THE GARDENS AT NORTH CAREFREE CONSTRUCTION DRAWINGS EL PASO COUNTY, STATE OF COLORADO

| GARDENS AT NORTH CAREFREE TITLE SHEET | |

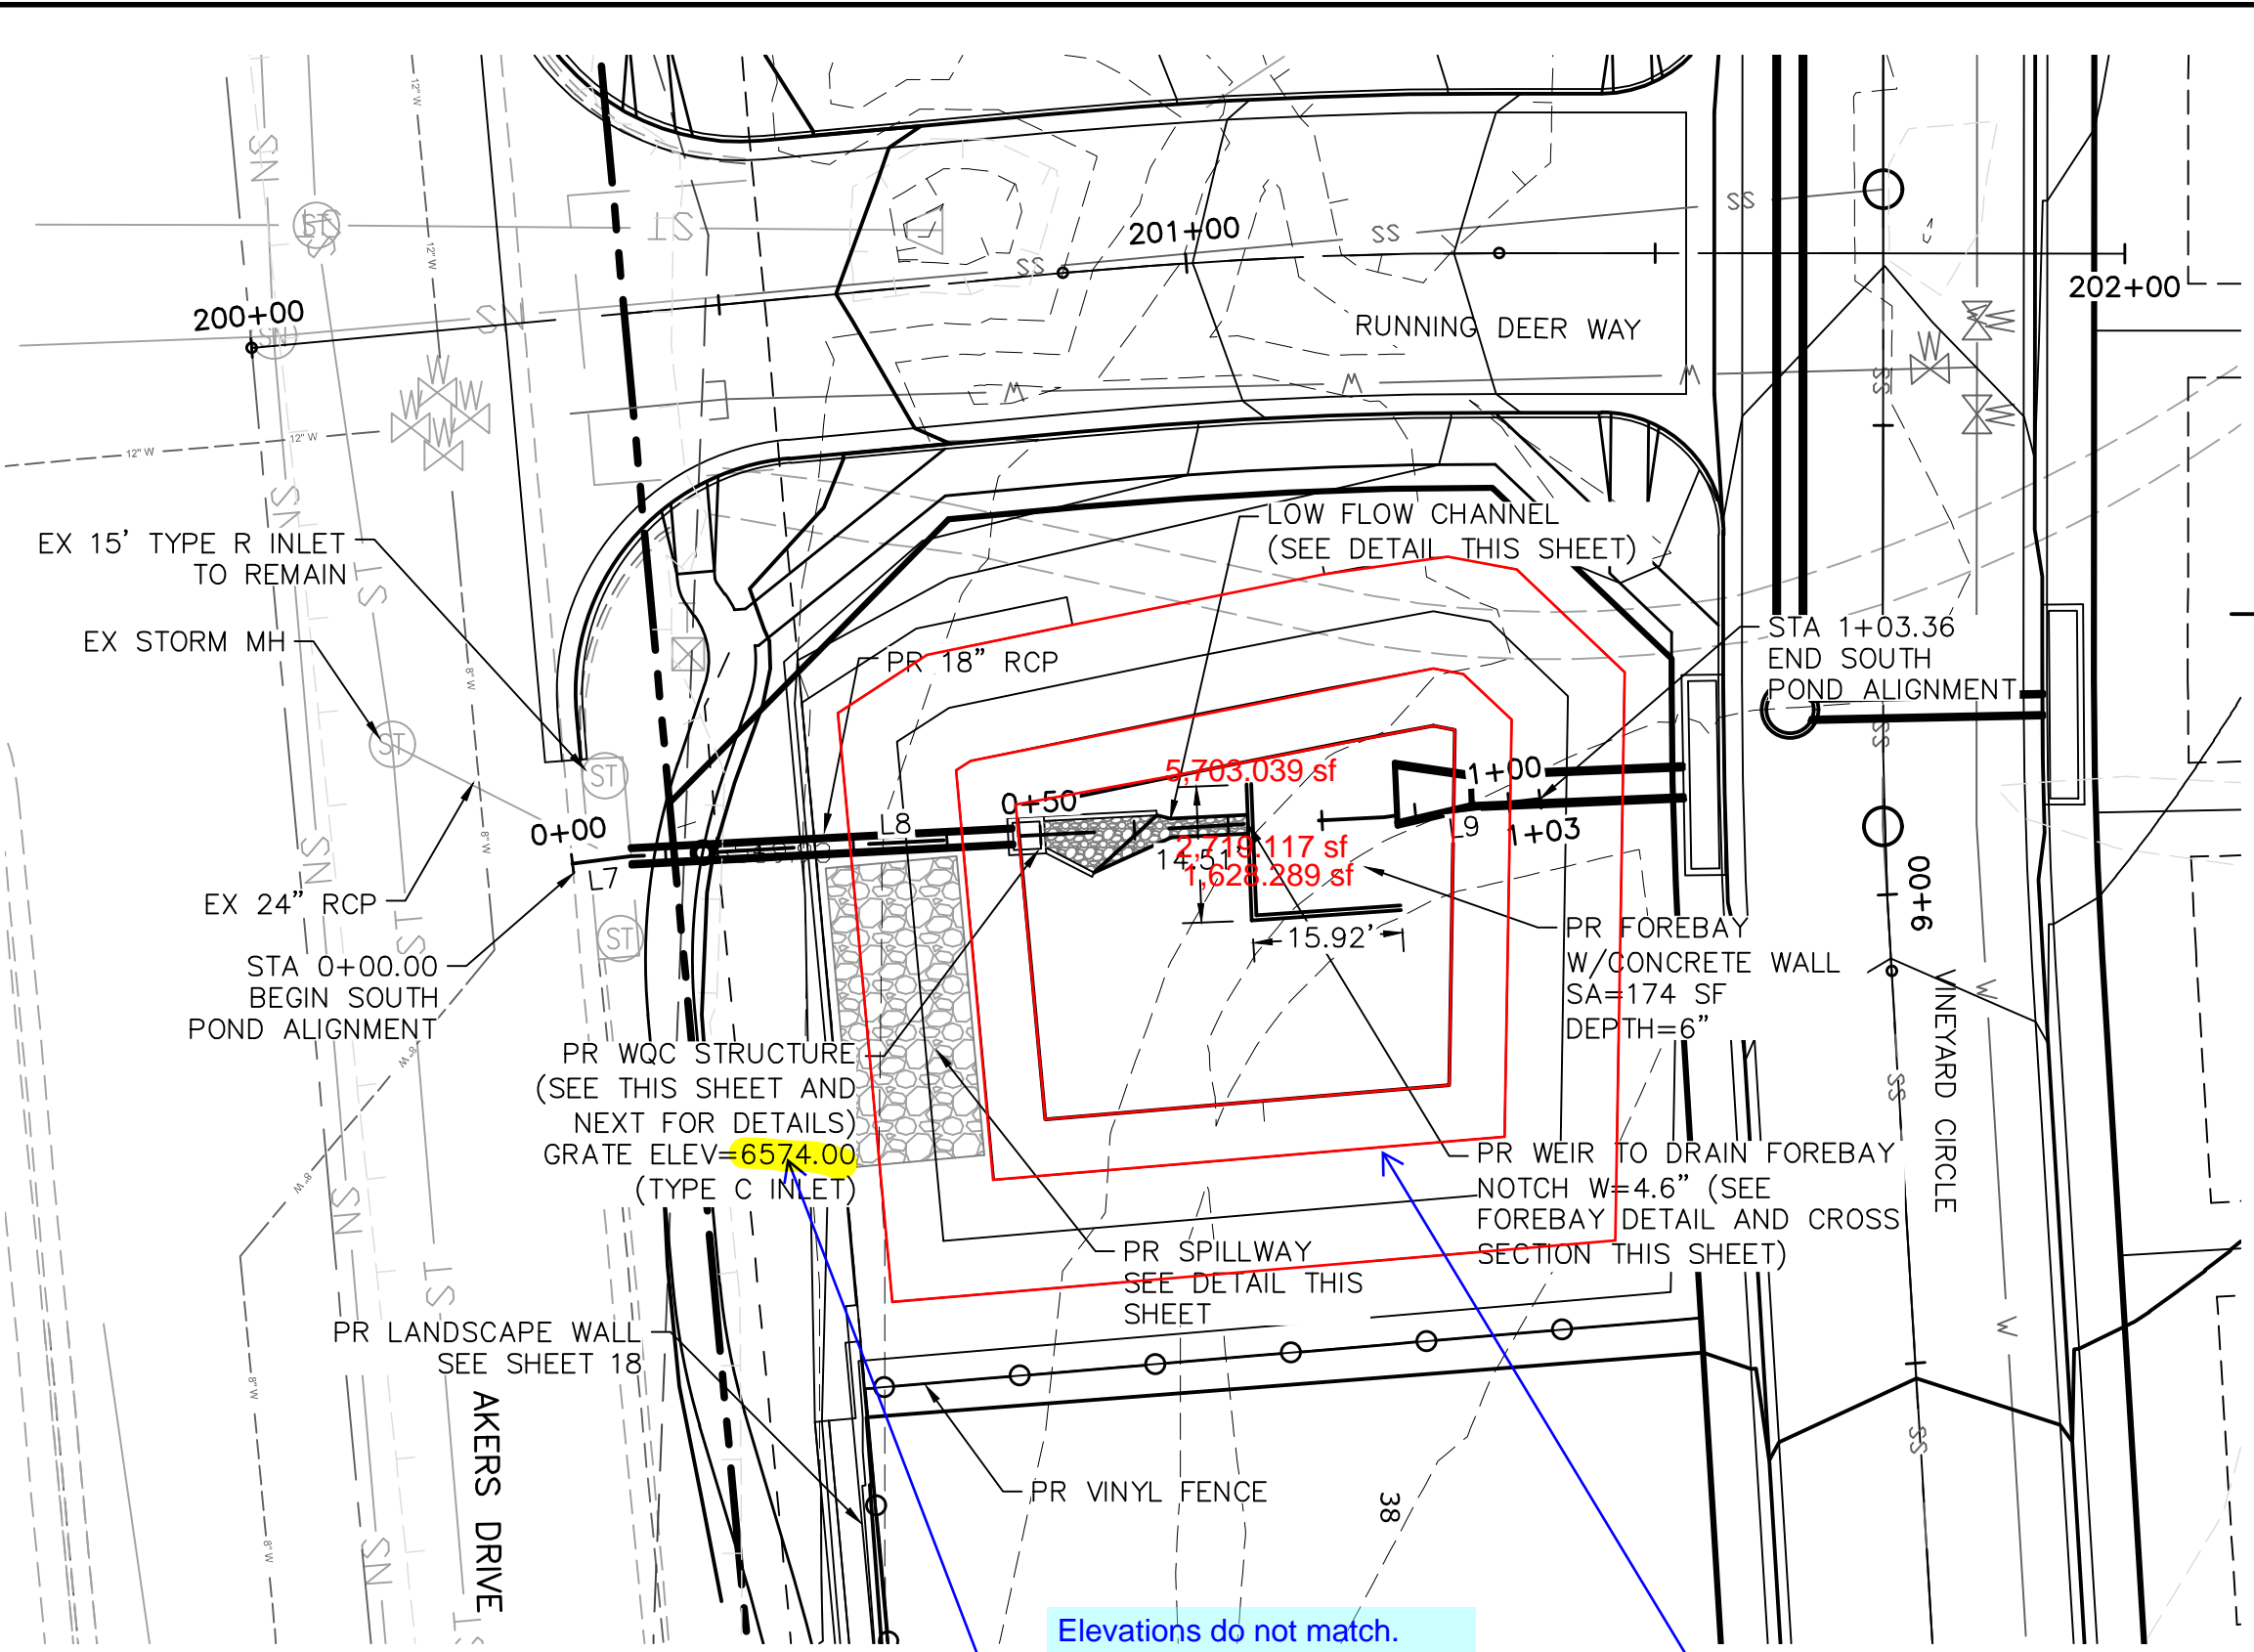
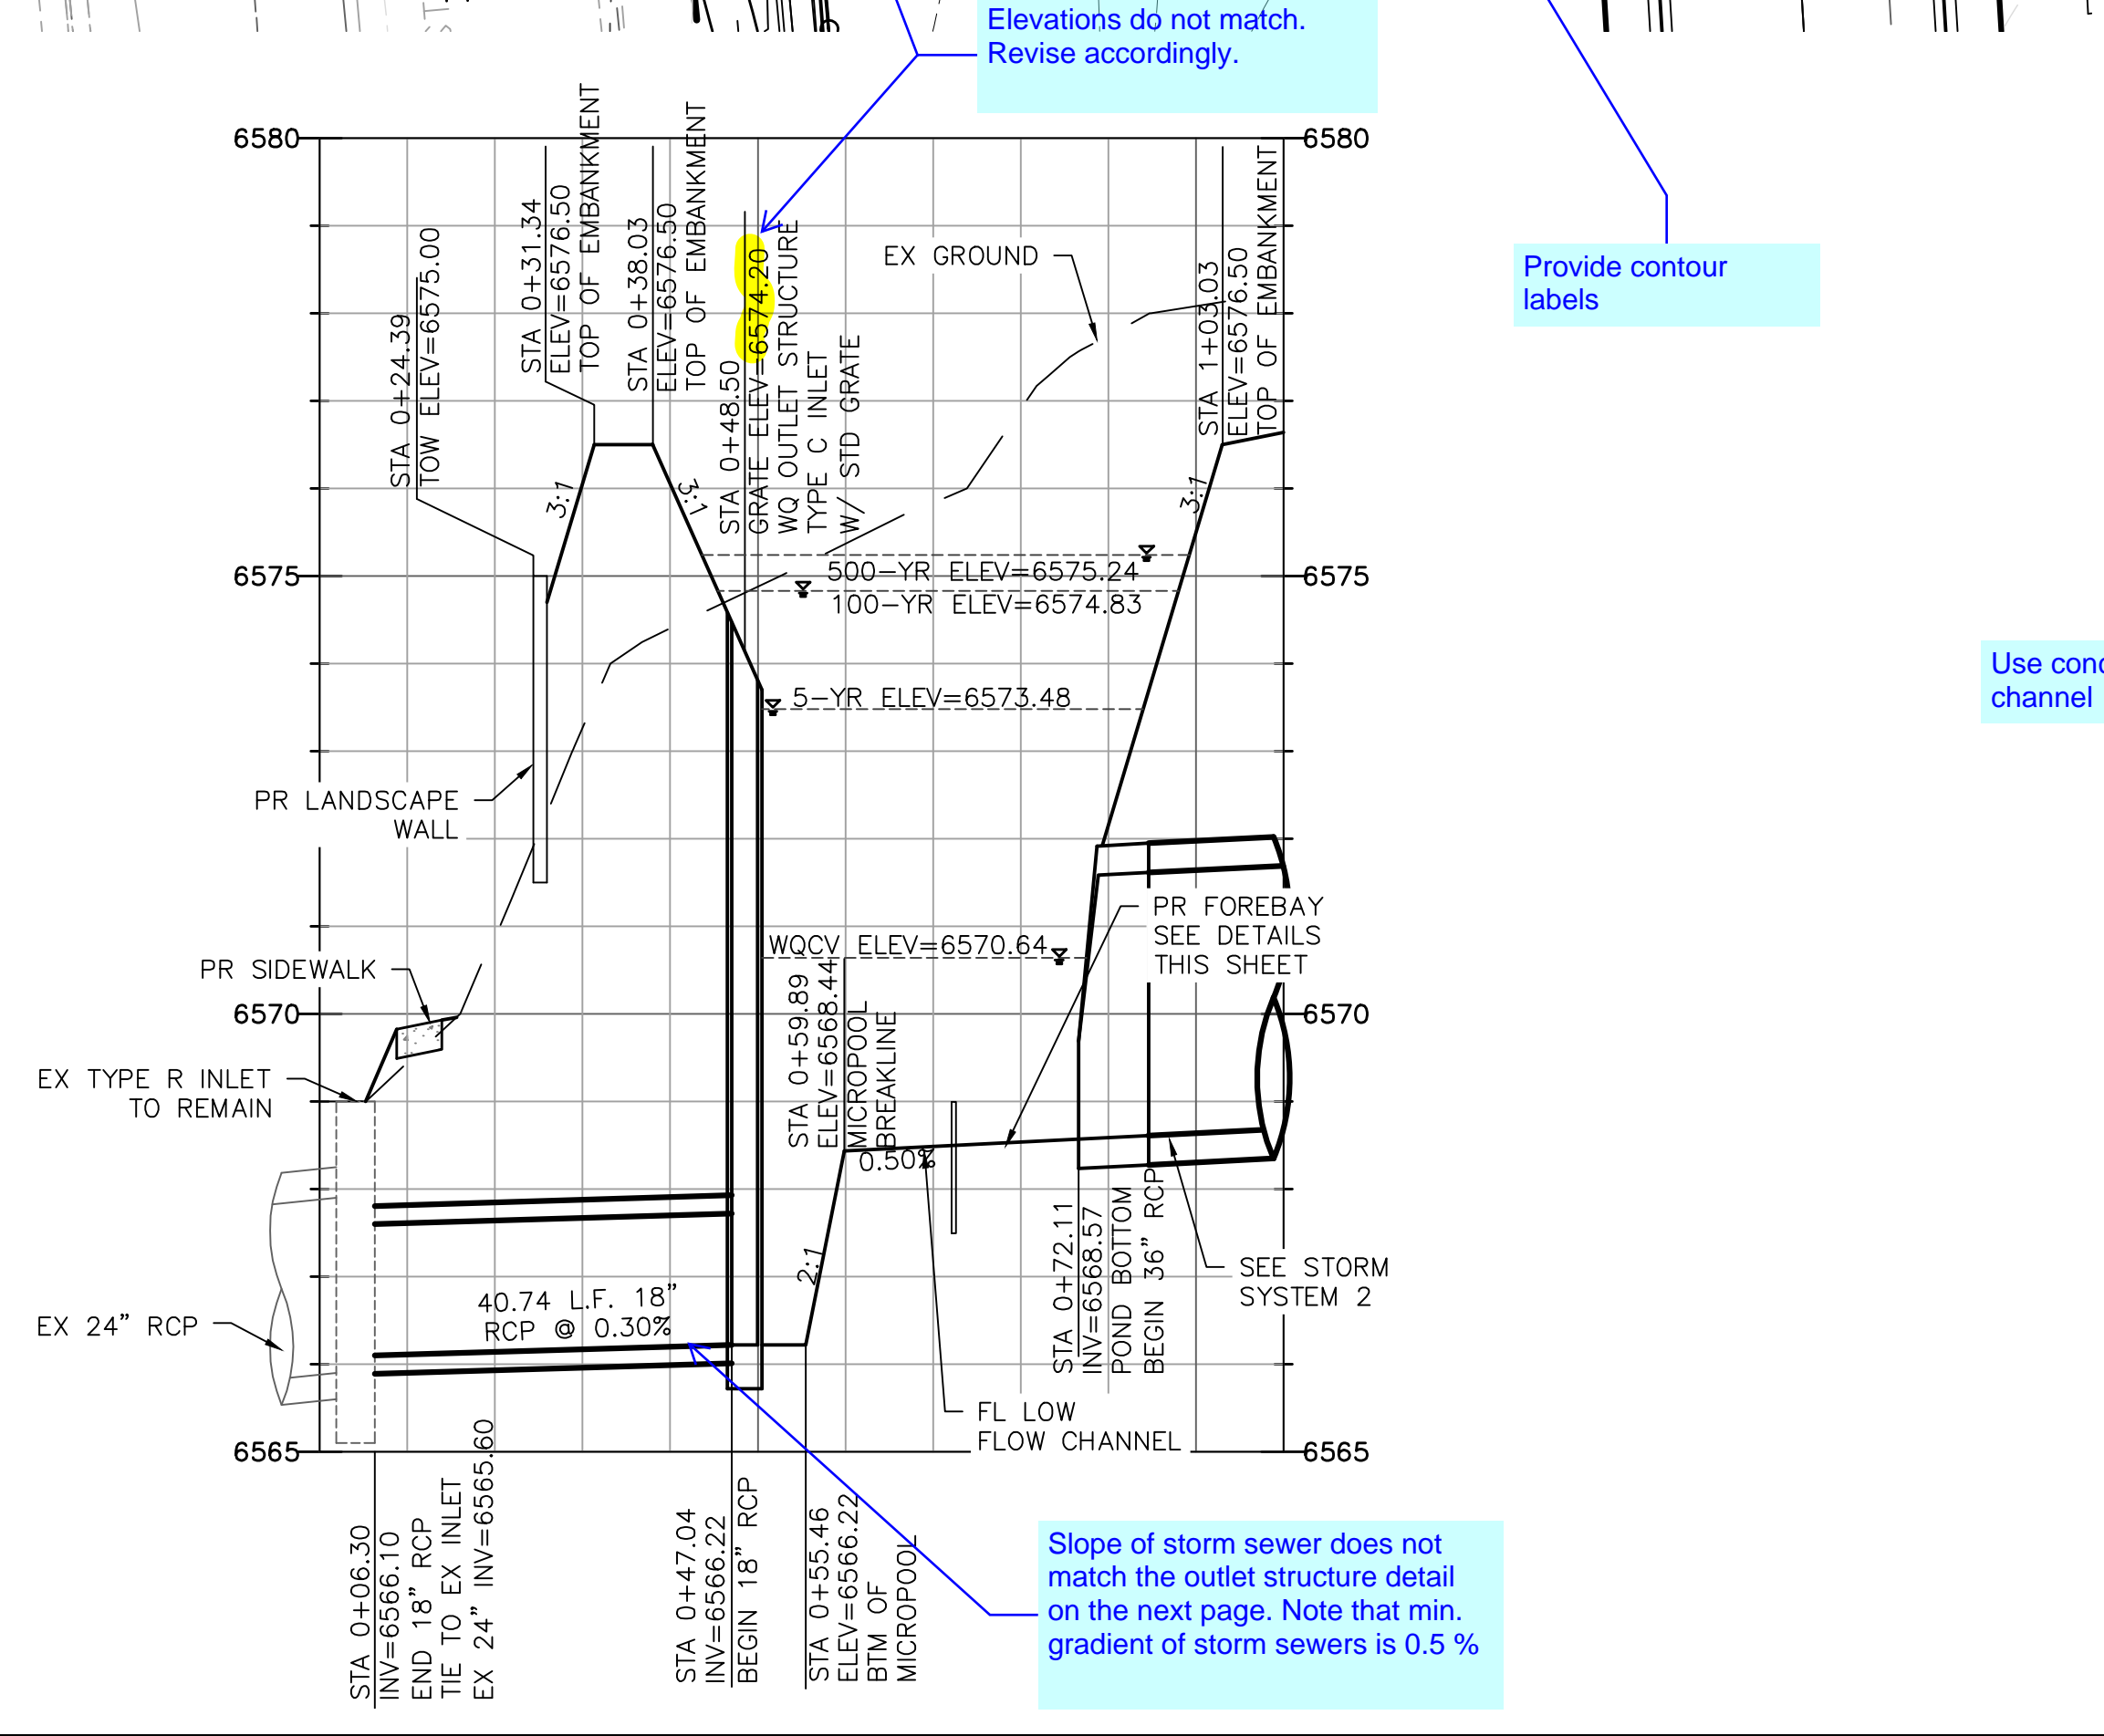
Elevations do not match. Revise accordingly.

Provide contour labels

Per the top of pond elevation shown, the spillway end slopes would not be 4:1. Revise accordingly. Ensure that there is still a 1' freeboard.

Slope of storm sewer does not match the outlet structure detail on the next page. Note that min. gradient of storm sewers is 0.5 %
